Submission of Further Information

Proposed Temporary Private Vehicle Park (Private Cars) for a Period of 3 Years in "Village Type Development" Zone, Lot Nos. 537 (Part), 538 (Part), 540 S.A (Part) and 541 S.A (Part) in D.D. 218, Ma Kwu Lam Village, Sai Kung North, New Territories

Further Information (4) for Planning Application Nos. A/NE-SSH/155
Response-to-Comment

Comments from Drainage Services Department received on 31.5.2024

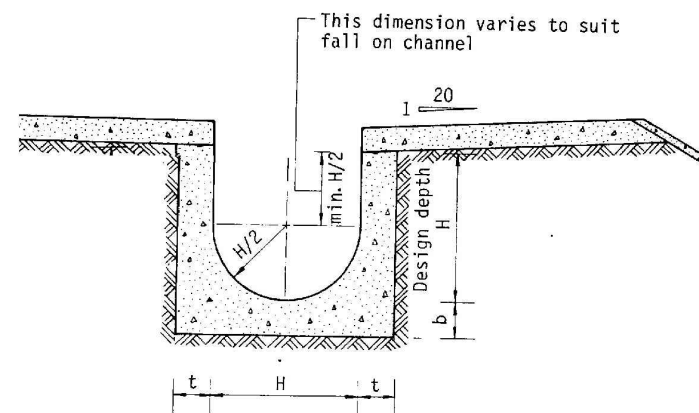
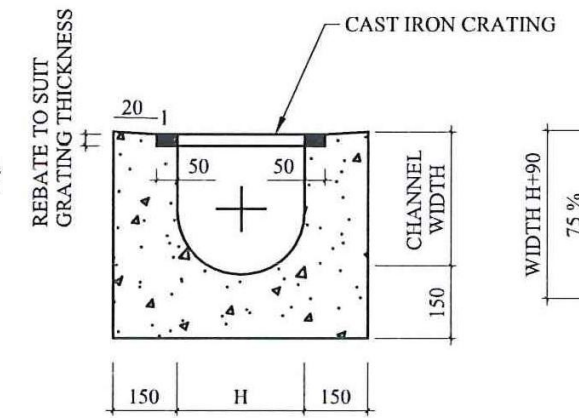
| I.	Comment	Response
(a)	Supporting calculations to demonstrate that the proposed drainage system and the existing downstream drain/channel has adequate capacity to convey the runoff to be discharged arising from the proposed development. (Checking for existing 250UC and its downstream for SSH_155)	Please refer to attached drainage calculations for details.

(b)	Please justify your proposed catchment area. (Please provide support evidence for all directions of the sites)	Ground levels of surrounding area are indicated on Plan 4.2a to justify the proposed catchment area.

(c)	The drainage flow path from the development to the public drainage system / streamcourse / sea / any recognized drainage facilities should be provided in association with supporting site photos for the captioned submission. (Please provide downstream information of existing250UC for SSH_155).	Please refer to the attached site photo showing the drainage flow path to local village drainage facilities.
